CASE SUMMARY SHEET**CASE NUMBER: V22-11-33****DATE RECEIVED: September 30, 2022****DATE OF MEETING: November 8, 2022 and December 13, 2022****Address: 200 Lafayette****Subdivision: Old Town of Mandeville****Zoning District: R-1 Single Family Residential****Property Owner: Patrick and Cindy Connolly****REQUEST: V22-11-33 – Patrick and Cindy Connolly request a variance to CLURO Section 9.2.5.7 Live Oak Protection Requirements, Sq 29B Lot 4A, R-1 Single Family Residential, 200 Lafayette****CASE SUMMARY:**

CASE SUMMARY SHEET

CASE NUMBER: V22-11-34

REQUEST: V22-11-34 – Lisa Landry requests a variance to CLURO Section 9.2.5.5. Landscape Requirements in Districts Other than Low-Density Residential, Sq 18 Lot 8, B-3 Old Mandeville Business District, 424 Girod St.

Photo No. 1

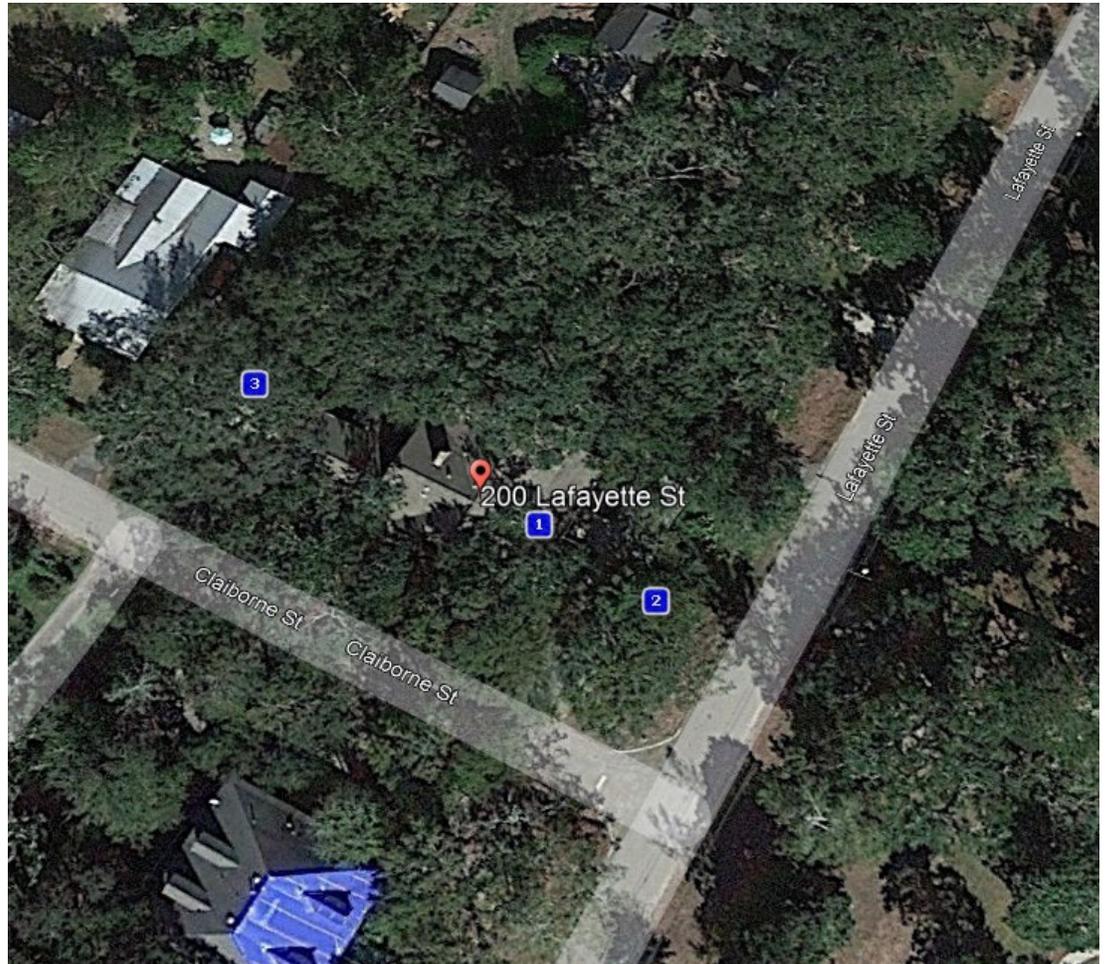
The tree subject trees that need immediate attention, are labeled on Photo # 1 of the attached Photo Log.

Tree # 1 – This subject tree is a mature Live Oak (*Quercus virginiana*) tree with a DBH of 28". The tree is located in your front yard, near to the front walkway. In fact, the tree is only feet away from your home (see Photos # 2 - # 8). The subject tree has been struck by lightning years ago, as the scar and old wound is clearly visible on the side opposite of the home, where guests would pull into your driveway. The lightning strike wound has not closed off completely and there are areas along the wound that are soft and decayed, especially at the base of the tree as seen in photo # 4 of the attached Photo Log). This subject tree also has grown near to other trees in stark competition for space and sunlight which has led to phototropism and a severe lean over the home. Visual evidence of decline can be seen in the crown of this tree in the tip deadwood that is present. This subject tree clearly presents an imminent threat to your home and should be removed now.

Tree # 2 – This subject tree is a young Water Oak (*Quercus nigra*) tree that is in the front yard of the property (see photo # 1 of the attached Photo Log). This tree is native to the region, and is prolific however, it is a terrible urban tree, in my opinion, largely due to growth habit and the growth characteristics of this species. This tree has a co dominant stem, with a tight "v" crotch which has formed inclusion. This tree will fail, and it is highly likely that it will fail at this point. This tree presents a risk to your property, adjacent roadways, and utilities overhead. This tree should be removed now to mitigate the risk of failure of this tree.

Tree # 3 – This subject tree is a mature Live Oak tree that is located near the driveway and can also be found in photo # 1 of the attached Photo Log. Formosan Termites were discovered in this tree. The tree appears to be in good health and stable. The Formosan termites will chew and destroy wood, both living and non-living cellulose. So, a treatment has been recommended for this tree that involves the use of termiticide to kill these pests. The tree does not present a risk to the home or neighboring homes;

1 SITE PLAN - NEW
01.10 Scale: 1/8" = 1'-0"

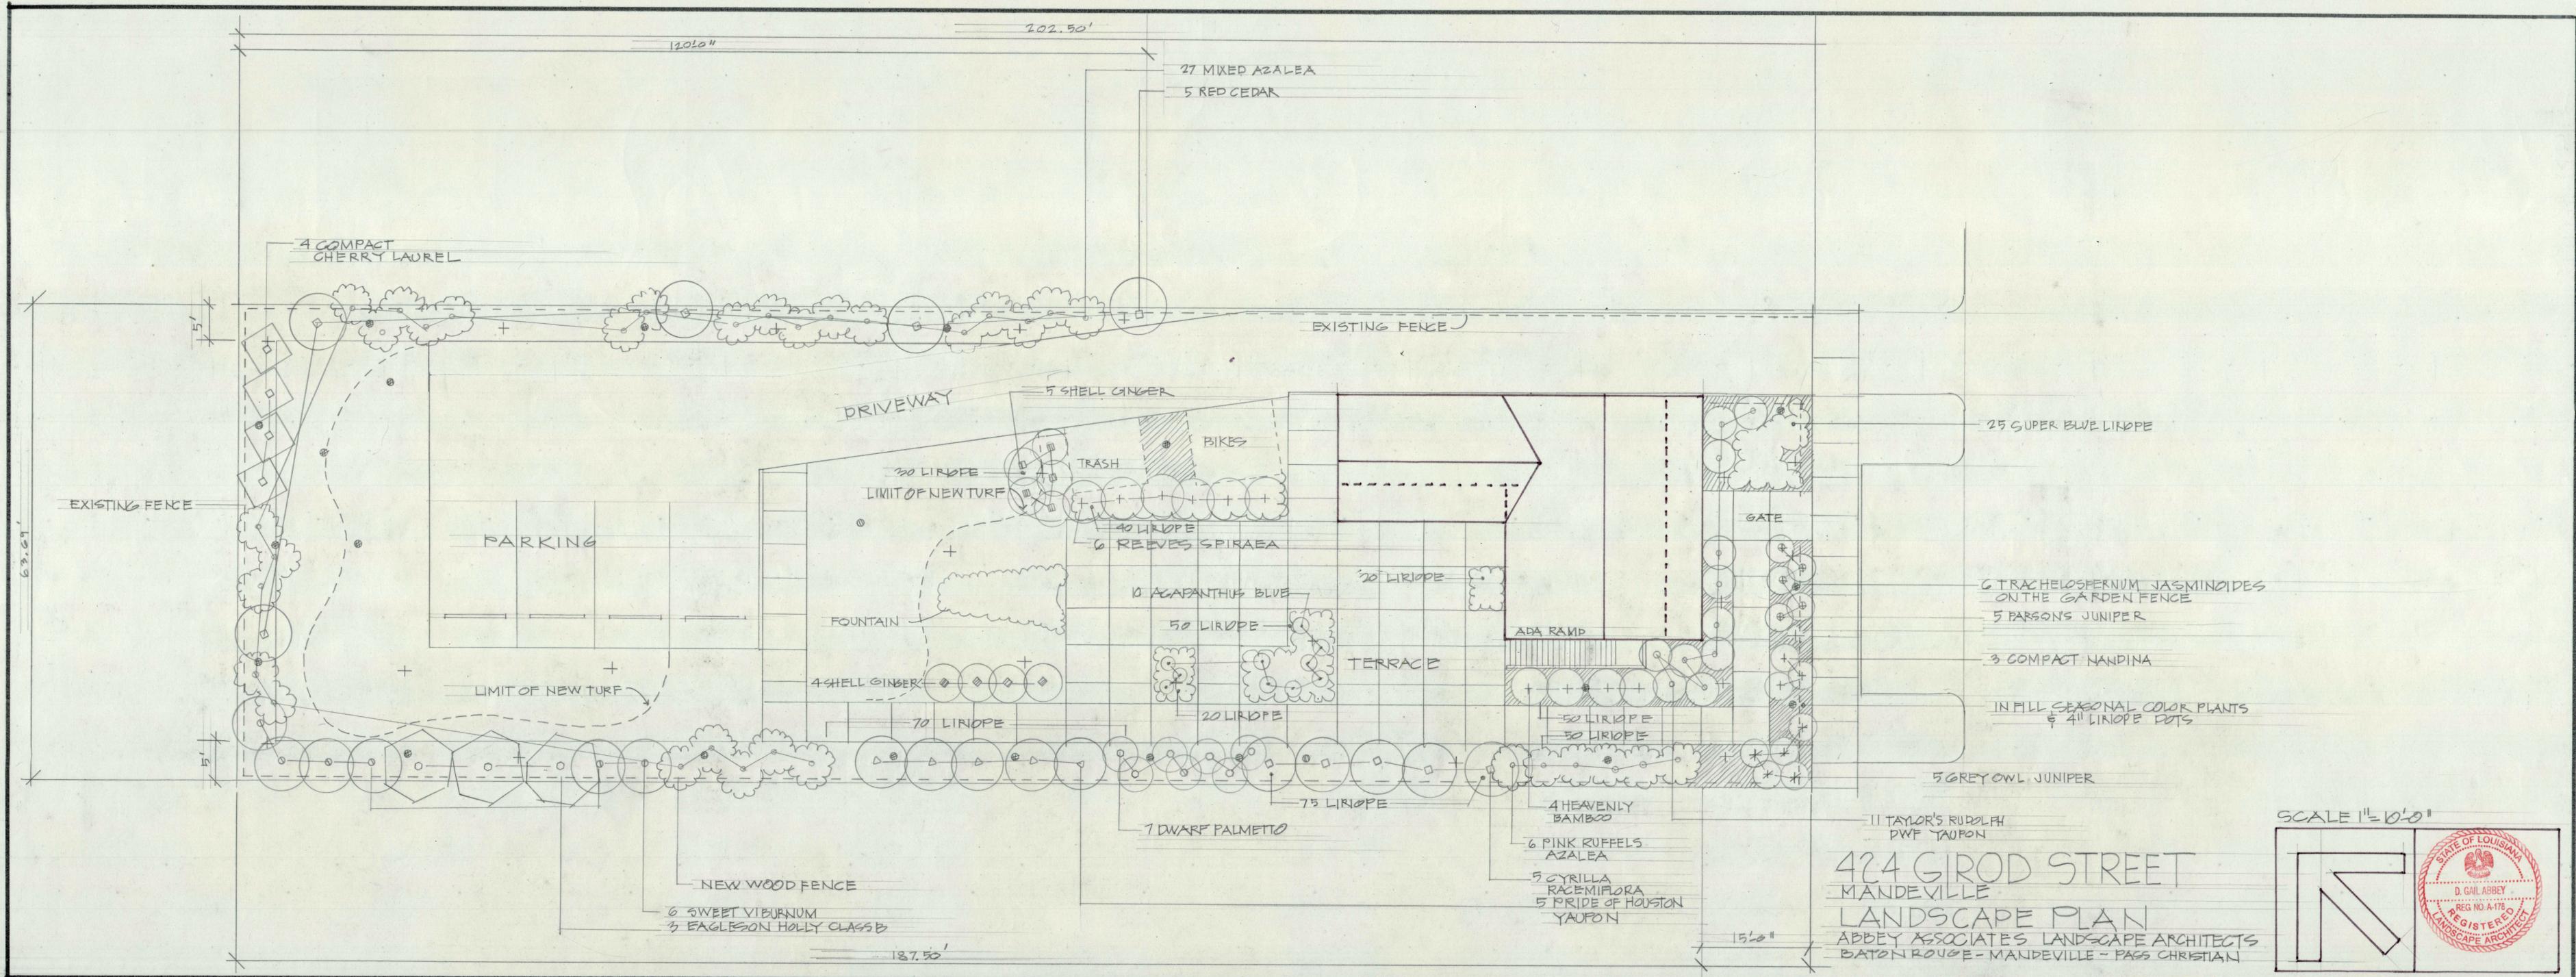
Greenbelt Requirements – Girod St – 63.95 L.F.					
1 Class ‘A’ per 25 L.F.					
1 Class ‘B’ per 25 L.F.					
	Required	Preserved	Proposed	Needed	Conforms With CLURO
Required Greenbelt Area	15’	-	15’	-	YES
Access Through Greenbelt	12’	-	11.1’	-	YES
Tree Preservation Within Greenbelt	All	2	-	-	YES
Underbrush Preserved	N/A	-	N/A	-	YES
Class ‘A’ Tree	2	1	1	-	YES
Class ‘B’ Tree	2	1	0	1	NO

North Buffer Zone Requirements – 202.5 L.F.					
1 Class ‘A’ per 25 L.F.					
1 Class ‘B’ per 10 L.F.					
1 Native Shrub per 10 L.F.					
	Required	Preserved	Proposed	Needed	Conforms With CLURO
Class ‘A’ Trees	8	1	2	5	NO
Class ‘B’ Trees	20	0	8	12	NO
Native Shrubs	20	-	17	3	NO
Visual Screen Within Buffer Zone	Fence	-	No	Fence details	NO
Required Buffer Zone Depth	5 ft	-	None	5 ft buffer for SUP or Variance	NO

West Buffer Zone Requirements – 63.95 L.F.					
1 Class ‘A’ per 25 L.F.					
1 Class ‘B’ per 10 L.F.					
1 Native Shrub per 10 L.F.					
	Required	Preserved	Proposed	Needed	Conforms With CLURO
Class ‘A’ Trees	2	1?	2	1 Existing tree is not identified	YES
Class ‘B’ Trees	6	0	4	2	NO
Native Shrubs	6	0	11	0	YES
Visual Screen Within Buffer Zone	Fence	-	No	Fence Details	NO
Required Buffer Zone Depth	5 ft	-	5’	-	YES

South Buffer Zone Requirements – 202.5 L.F.					
1 Class ‘A’ per 25 L.F.					
1 Class ‘B’ per 10 L.F.					
1 Native Shrub per 10 L.F.					
	Required	Preserved	Proposed	Needed	Conforms With CLURO
Class ‘A’ Trees	8	1	6	1	NO
Class ‘B’ Trees	20	0	10	10	NO
Native Shrubs	20	-	27	0	YES
Visual Screen Within Buffer Zone	Fence	-	Unknown Fence	Fence Details	NO
Required Buffer Zone Depth	5 ft	-	None	-	YES

Plan Preparation Requirements – Contents of Landscape Plan			
	Provided	Needed	Conformance With CLURO
Scaled Drawing	Yes	-	YES
Dimensioned as Required	No	Dimensions Missing on Tree Plan	NO
Location, Type, Size of Proposed Landscaping	Yes	Should be on one page	YES
Required/Proposed Legend with S.F. of Proposed Landscape Areas	No	See Requirements under Notes	NO
Landscape Architect’s Information and Stamp	Yes	Missing some see Requirements under notes	YES

- Plan should all be on one page.
- Plant counts on plans are off and need to be corrected.
- Some plants are not identified on the plans so unsure if counts are correct in plan review.
- Red Cedar is listed on the “Shrub” page but is a tree.
- Buffer and Greenbelt locations only shown on the “Shrub” page.
- Due to the devastating effects of the Emerald Ash Borer ash trees should be substituted for another type of tree.
- Waxleaf Ligustrum is a shrub and not a tree.
- Eagleston Holly is a tree and should be on the Tree plan.
- Yaupon is a tree and should be on the tree plan.
